Access Compliance Report

Public Rights-of-Way (Curb Ramps)

Intersection ID: 3823	Main Street: BROWNE'S_FERRY_RD	Cross Street: CORNERSTONE_DR	Location: NW
ADA ID: D88265321873	Ramp Type: Perp	Initial Pass/Fail: Fail	Overall Compliance: No
Severity Score: 8.75			
Codes/Mitigation Info/Possible Solution		Field Measurements/Component Compliance

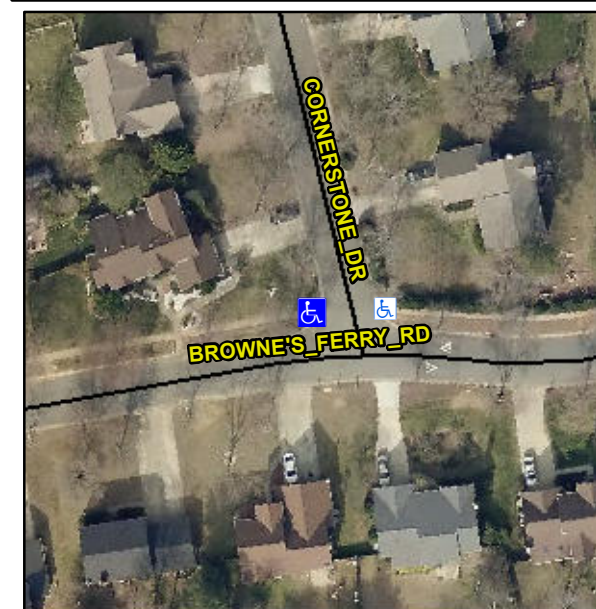
Compliance	Description	Data	Compliance	Description	Data
N/A	Ramp Length (in)	88.5	Yes	Ramp Slope (%)	6.6
No	Ramp Width (in)	45.0	Yes	Ramp XSlope (%)	1.1
N/A	Flare Type LT	N/A	N/A	Flare Type RT	N/A
N/A	Flare Slope LT (%)	N/A	N/A	Flare Slope RT (%)	N/A
N/A	Flare Traversable LT?	N/A	N/A	Flare Traversable RT?	N/A
N/A	Landing Length (in)	N/A	N/A	DWS Provided?	N/A
N/A	Landing Width (in)	N/A	N/A	DWS Contrast?	N/A
N/A	Landing Slope (%)	N/A	N/A	DWS Length (in)	N/A
N/A	Landing X Slope (%)	N/A	N/A	DWS Full Width?	N/A
N/A	Landing Curb? (Y/N)	N/A	N/A	DWS Offset (in)	N/A
N/A	Shared Landing?	N/A			
N/A	Gutter Ponding?	N/A	N/A	Gutter Slope (%)	N/A
N/A	Gutter Lip Ht (in)	N/A	N/A	Gutter X Slope (%)	N/A
N/A	Painted X Walk1?	No	N/A	Painted X Walk2?	N/A
	X Walk 1 Direction	To E		X Walk 2 Direction	N/A
N/A	X Walk 1 Width (in)	N/A	N/A	X Walk 2 Width (in)	N/A
	X Walk 1 Slope (%)	3.1		X Walk 2 Slope (%)	N/A
	X Walk 1 X Slope (%)	3.3		X Walk 2 X Slope (%)	N/A

Remove & Replace Entire Ramp.

R304.5.1
